2020 SMP Package III (Morales and E. Huff)  
Solicitation Number: CO-00230  
Job No.: 18-5012 & 18-5512

**ADDENDUM 1**  
November 26, 2018

2020 SMP PACKAGE III (MORALES, E. HUFF) WATER PLANS PROJECT LAYOUT

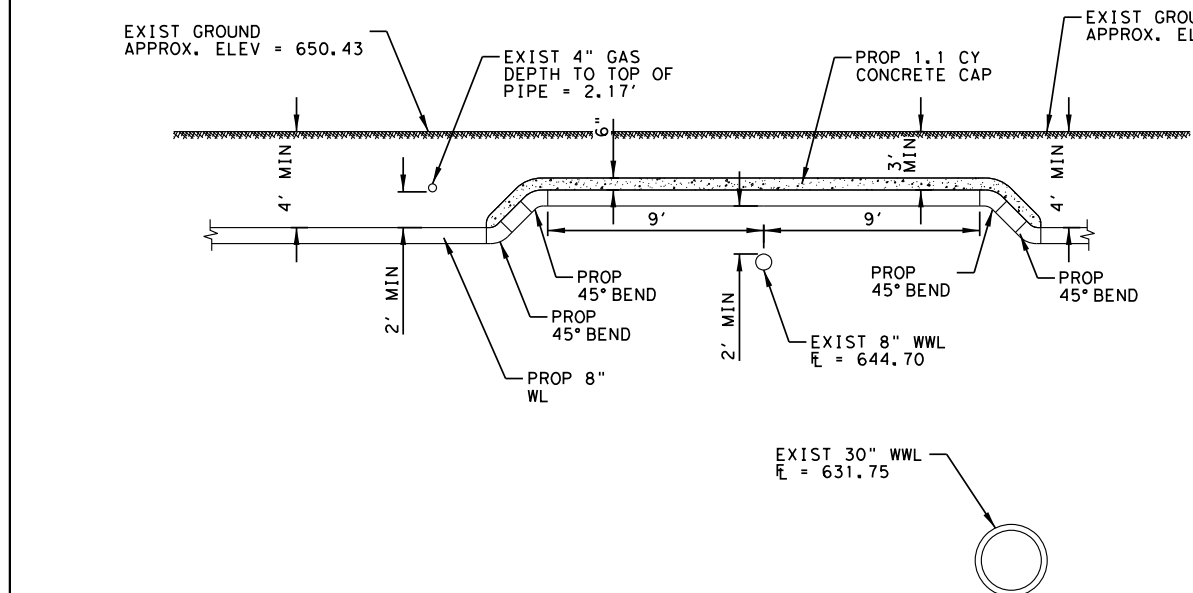
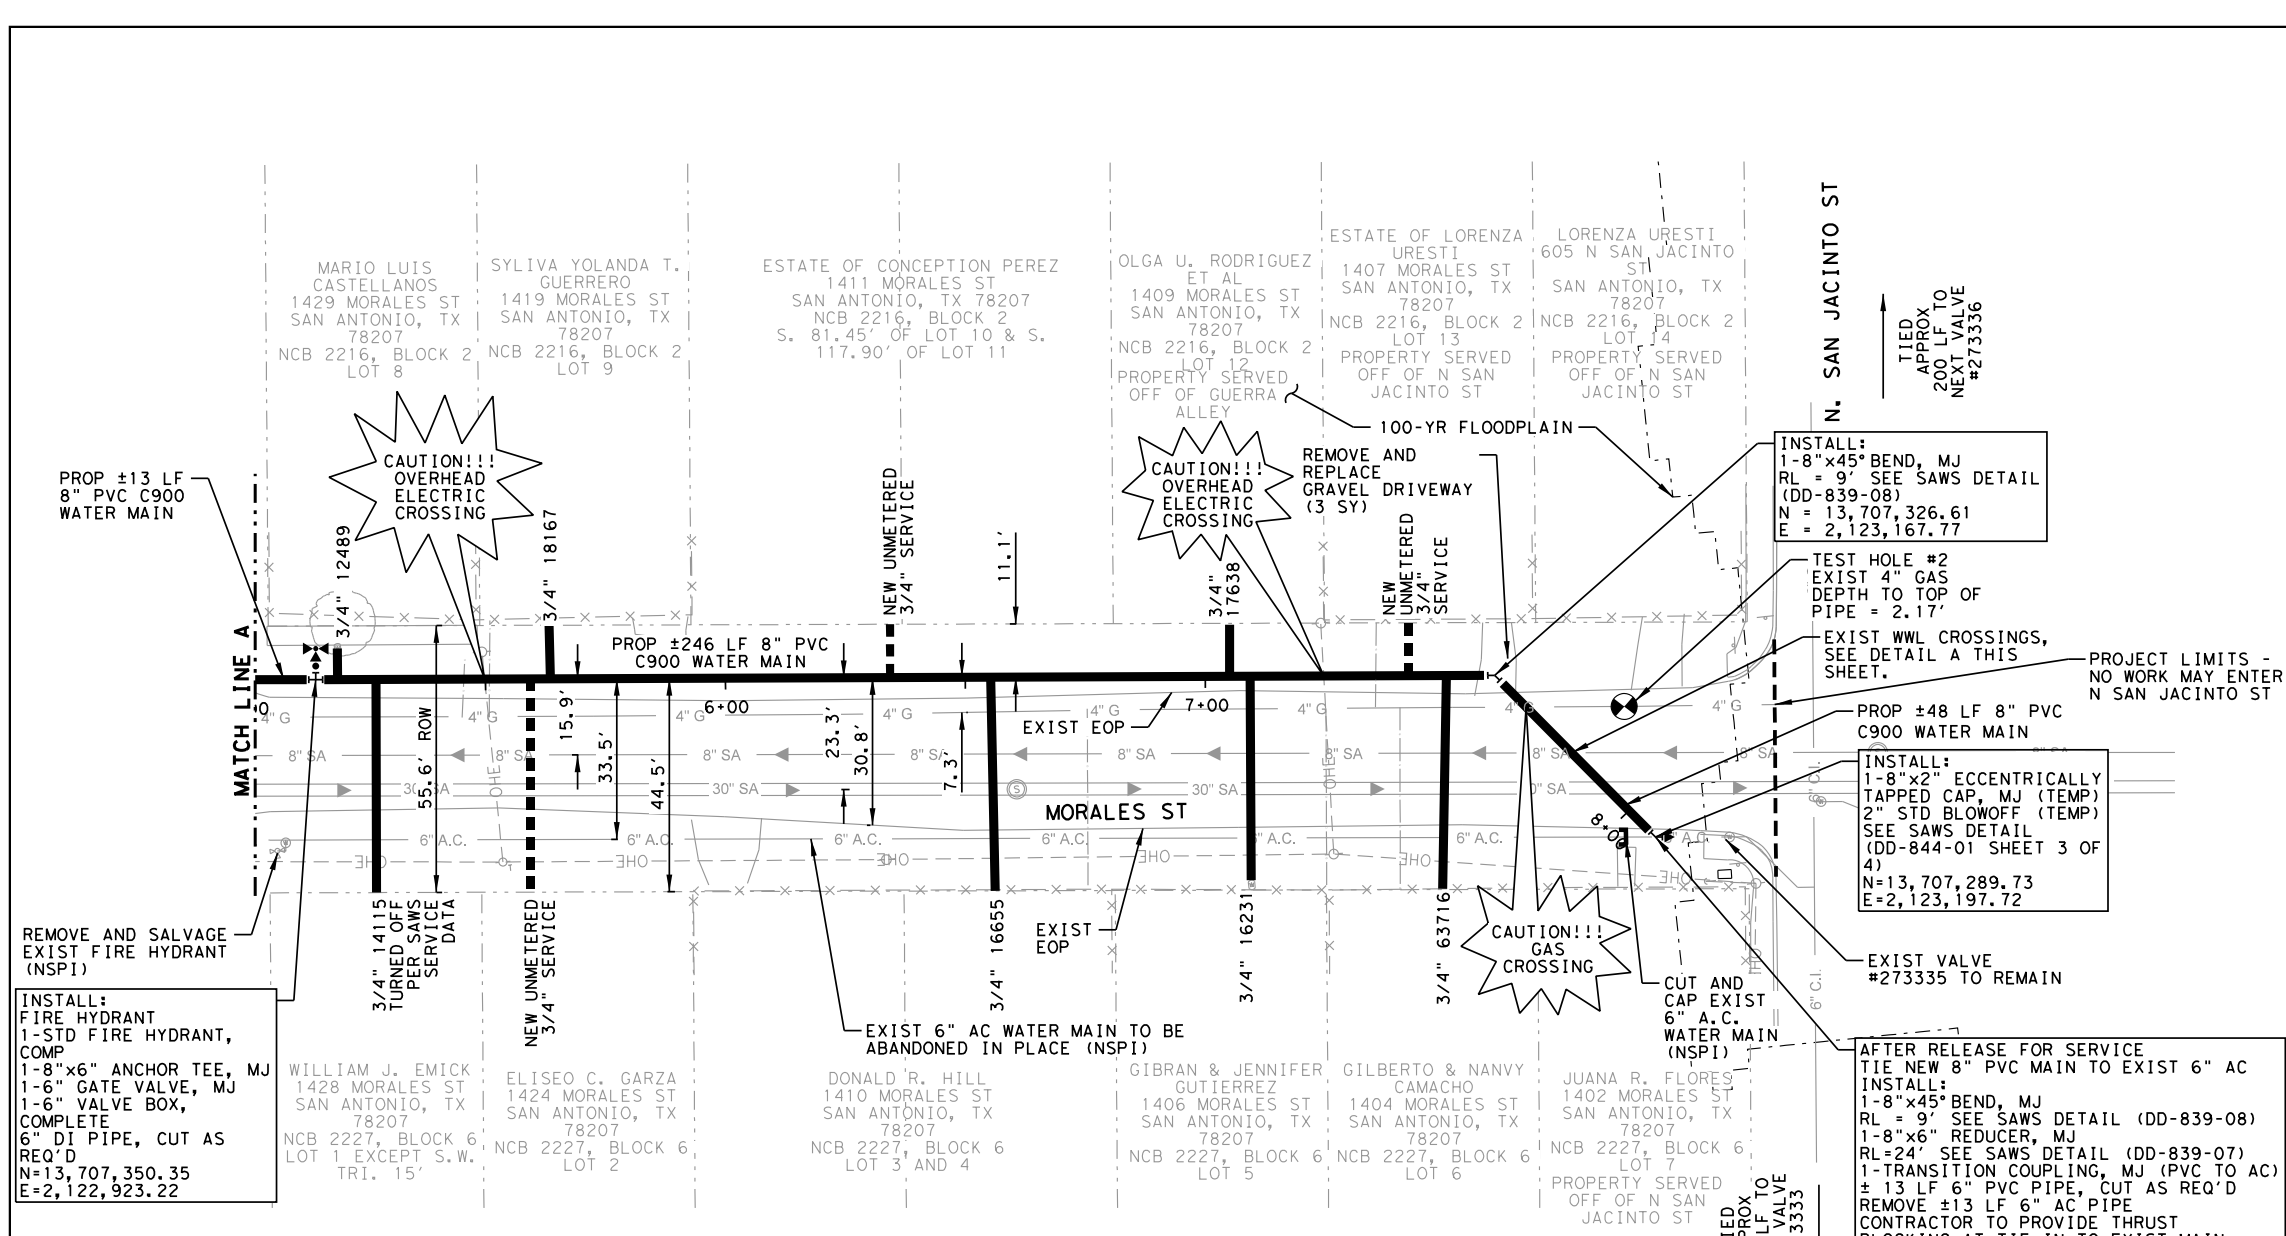
1. Replace sheets 2, 3, and 8-10 with the attached sheets. The plans were modified to add and revise City of San Antonio notes for work within the 100-yr floodplain, and to revise the water alignment on Morales Street to avoid removing existing trees.

NOTES FOR WORK WITHIN 100-YR FLOODPLAIN AT MORALES STREET:

1. PRIOR TO CONSTRUCTION, THE CONTRACTOR SHALL OBTAIN ALL REQUIRED STORM WATER PERMITS, FEES, AND APPROVALS. NO CONSTRUCTION OR FABRICATION SHALL BEGIN UNTIL THE CONTRACTOR HAS RECEIVED AND THOROUGHLY REVIEWED ALL PERMITS REQUIRED FOR CONSTRUCTION IN DRAINAGE EASEMENTS, RIGHT-OF-WAYS, AND FLOODPLAINS.

2. THE CONTRACTOR SHALL NOTIFY STORM WATER ENGINEERING AT LEAST 24 HOURS PRIOR TO THE INSTALLATION OF ANY DRAINAGE FACILITY WITHIN A DRAINAGE EASEMENT OR STREET RIGHT-OF-WAY NOT INDICATED ON THE CONSTRUCTION PLANS.

3. THE CONTRACTOR IS RESPONSIBLE FOR PROTECTING EXISTING DRAINAGE FACILITIES FROM DAMAGE. ANY DAMAGE TO EXISTING DRAINAGE SYSTEMS, WHETHER OR NOT SHOWN ON THE PLANS, SHALL BE THE RESPONSIBILITY OF THE CONTRACTOR TO REPAIR AT HIS EXPENSE. THE CONTRACTOR SHALL NOTIFY STORM WATER ENGINEERING AT 210-206-8433 AS SOON AS CONFLICTS WITH UTILITIES ARE ENCOUNTERED OR ANY DRAINAGE SYSTEM IS DAMAGED DURING CONSTRUCTION.

4. CONSTRUCTION SPOILS WILL NOT BE ALLOWED TO BE DEPOSITED ANYWHERE WITHIN A DRAINAGE EASEMENT, RIGHT-OF-WAY, OR FLOODPLAIN WITHIN THE LIMITS OF THE PROJECT AND SHALL BE DISPOSED OFFSITE IN COMPLIANCE WITH CURRENT APPLICABLE REGULATIONS.

5. NO STRUCTURE, FENCES, WALLS, LANDSCAPING, OR OTHER OBSTRUCTIONS THAT IMPEDE DRAINAGE SHALL BE PLACED WITHIN THE LIMITS OF THE DRAINAGE EASEMENTS SHOWN ON THE CONSTRUCTION DOCUMENTS.

6. UPON COMPLETION OF TRENCHING, THE AREA WILL BE BACKFILLED AND COMPACTED TO ITS ORIGINAL CONDITION. TRENCHES/BORE PITS TO BE OPEN AND UNATTENDED LONGER THAN 24 HOURS SHALL BE PROTECTED TO WITHSTAND ALL HYDRODYNAMIC AND HYDROSTATIC FORCES AND PREVENT DOWNSTREAM IMPACTS. TRENCHES/BORE PITS TO BE OPEN LONGER THAN 30 DAYS AFTER STARTING EXCAVATION SHALL BE BACKFILLED WITH A SEMI-PERMANENT REPAIR BACKFILL.

7. IMPROVED SECTIONS OF EARTHEN CHANNELS AND/OR WATERWAYS WILL BE VEGETATED BY SEEDING OR SODDING. EIGHTY-FIVE PERCENT OF THE CHANNEL SURFACE AREA MUST HAVE ESTABLISHED VEGETATION BEFORE THE CITY OF SAN ANTONIO WILL ACCEPT THE CHANNEL FOR MAINTENANCE.
